# Access Compliance Report Public Rights-of-Way (Curb Ramps)

Main Street: IRVINE\_AVE Cross Street: MONTE\_VISTA\_AVE Location: NW

ADA ID: RPRK211018124809 Ramp Type: Type 1 - Perpendicular Diagonal Initial Pass/Fail: Pass Overall Compliance: No Severity Score: 5

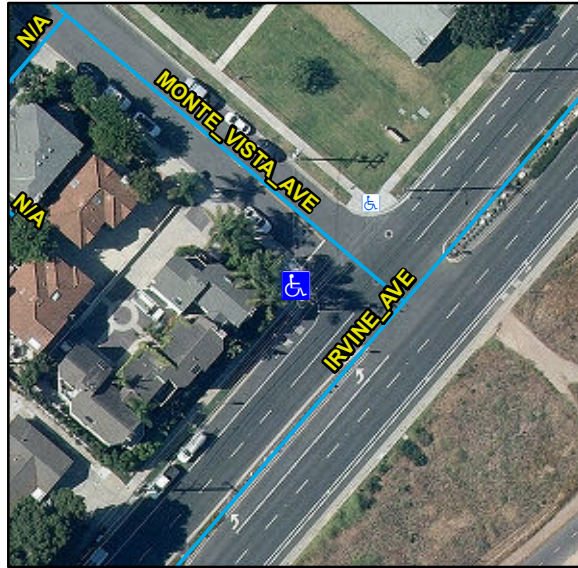
| Compliance | Description                           | Data | Compliance | Description                   | Data   |
|------------|---------------------------------------|------|------------|-------------------------------|--------|
| Yes        | Gutter Ponding                        | No   | No         | Curb Slope                    | 10.5   |
| No         | Gutter Run Slope (%)                  | 7.3  |            | Road Cross Slope (%)          | 7      |

Remove & Replace Curb Ramp With Two New Directional Ramps or Equivalent. Remove & Replace Gutter.

R304.2.2, R304.2.1, R304.5.4, STD 1115
